**Our Case Number:** ABP-317660-23  
**Planning Authority Reference Number:**

**Re:** Bus Connects Kimmage to City Centre core bus corridor scheme  
Kimmage, Dublin

Bord Pleanála Case reference: HA29N.317660  
Description of SID: Kimmage to City Centre Core Bus Corridor

Image 3: Current Junction Rathgar Avenue & Harolds Cross Road

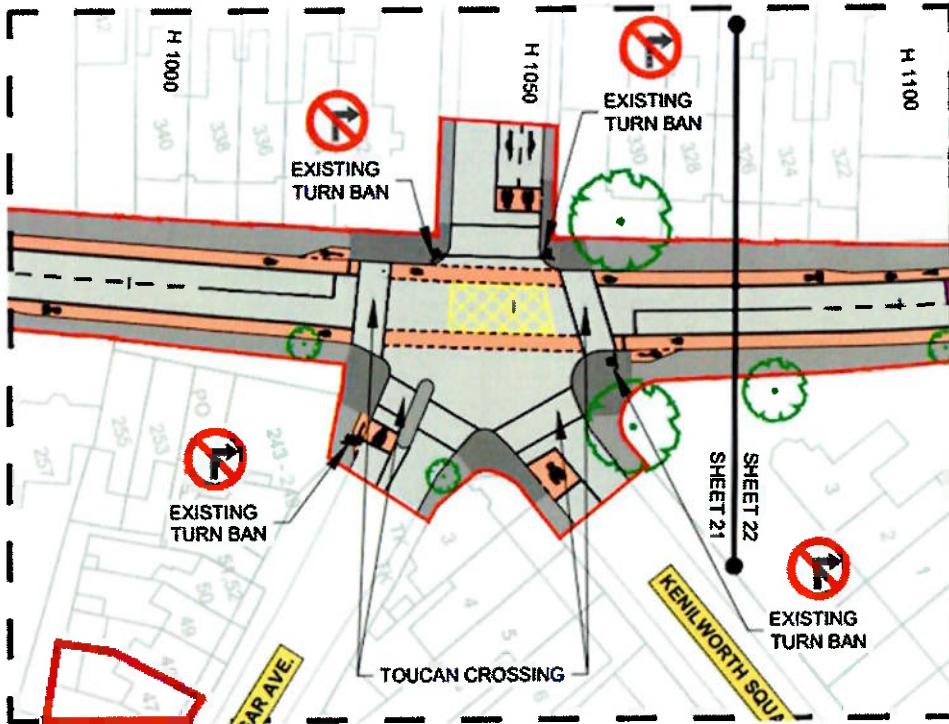
While we obviously recognise the benefits of better public transport and in principle support the Bus Corridor Scheme, we have very genuine concerns regarding the proposal to create a Bus Gate at the junction of Kenilworth Square North and Harold Cross Road (Image 3 & Image 4) with all westbound general traffic to be diverted via Rathgar Avenue as part of the proposed scheme (Image 5) which we would wish to have taken under consideration and addressed.

Image 5: All westbound general traffic to be diverted via Rathgar Avenue

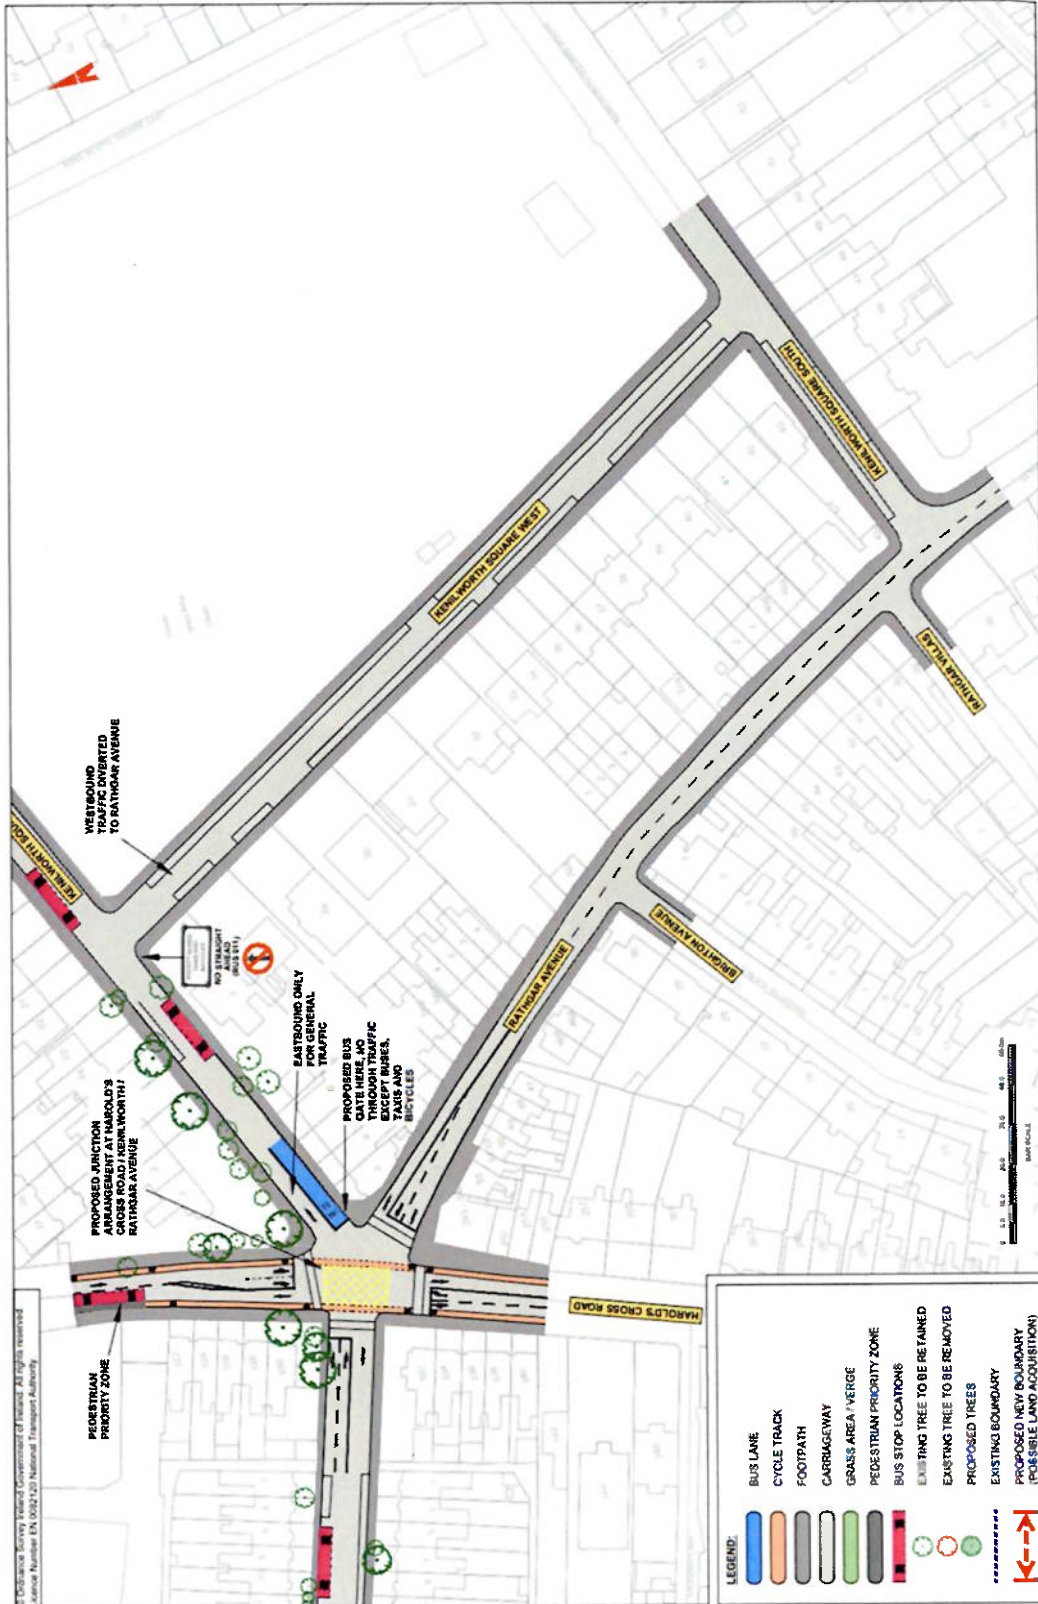
1. In the Planning Documentation, Environmental Impact Assessment Report, Chapter 06 - Traffic & Transport it is stated that the threshold impact assessment identified for the Proposed Scheme results in a negative impact for redistributed traffic at both AM and PM Peak Hours on Rathgar Avenue among other roads and this requires further traffic analysis with regard to Volume to Capacity ratios  $V / C$  ratios however no such analysis appears to have been done for Rathgar Avenue which is already a Rat Run and operating at saturation levels for during the peak hours of the day. The Increase of Flow Difference 196 (AM Peak Hour) and 198 (PM Peak Hour) would appear to be Voodoo Statistics (Excuse the phrase but I can think of no better). A proper analysis needs to be  $V / C$  ratios carried out before the Bus Gate should even be considered.

Image 6: Air Vents which are an essential element of the building

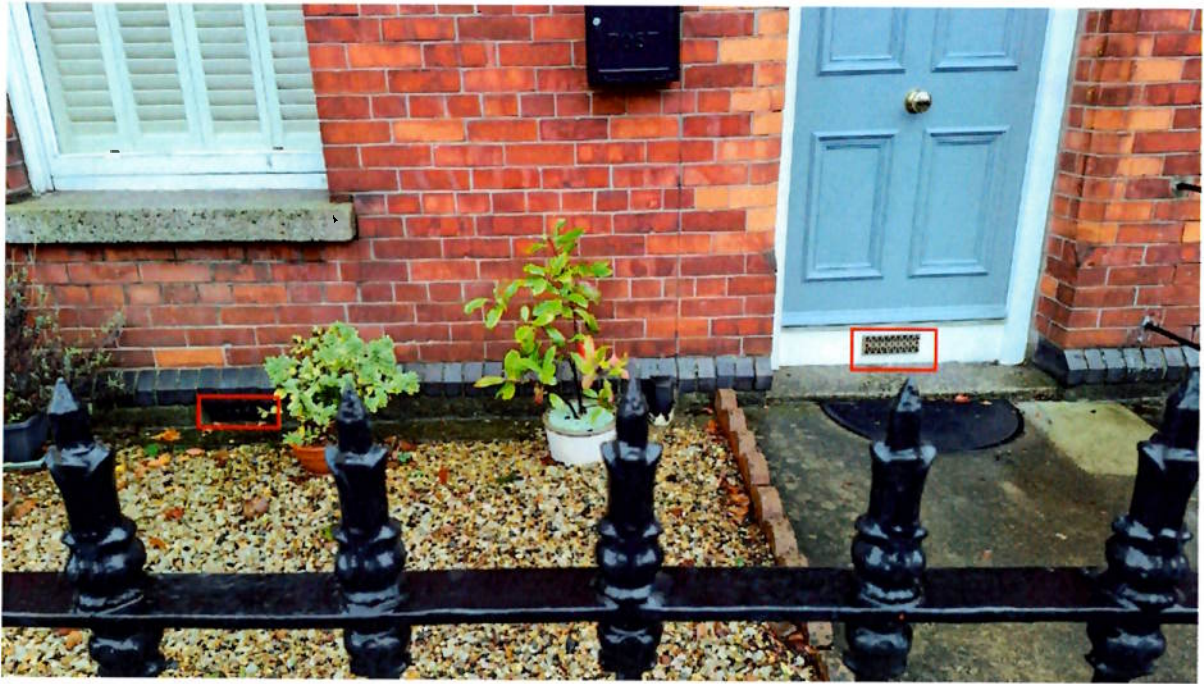
2. Our Primary concern however relates to Gullys and Drainage, as previously mentioned Rathgar Avenue at the junction to Harolds Cross Road comprises of a row a two-story red brick period property which are traditionally constructed with Sub-Floor Air Vents which are an essential part of the building construction (Image 6) and required to prevent damp maintain the fabric of the building. Unfortunately, the junction of Rathgar Avenue and Harolds Cross road is subject to Fluvial Flooding on a regular basis (Image 7 & Image 8) as rainwater flows down Rathgar Avenue from Terenure Road East and also flows around the corner from Harolds Cross Road (due to seriously bad road and footpath design) and this is only increasing with Climate Change. With the proposed massive increase redistributed traffic due to the proposed Bus Gate, it is inevitable that our property at that of our neighbours will be flooded by the bow wave of the additional traffic. That fact that this obvious fact, which any resident of Rathgar Avenue could have pointed out, has not even

Image 7: Fluvial Flooding on the junction of Rathgar Avenue and Harolds Cross road

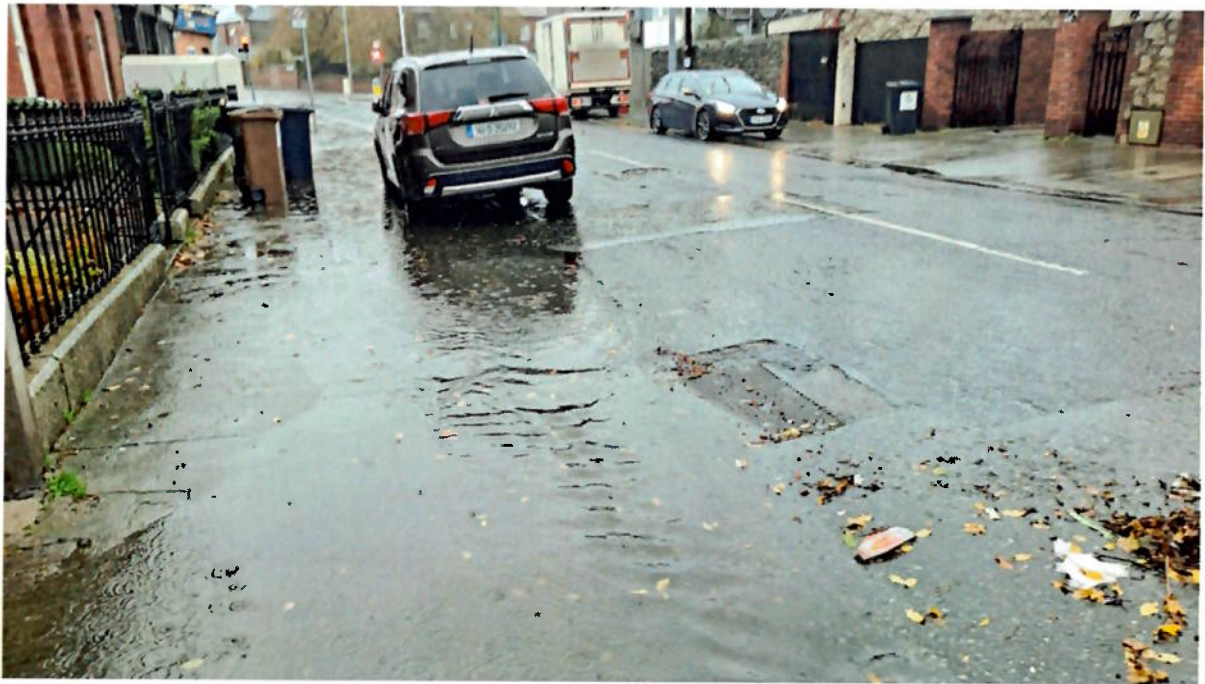
been considered in the Environmental Impact Assessment Report is extremely concerning. A proper analysis of Drainage on Rathgar Avenue needs to be carried out before the proposed Bus Gate should even be considered.
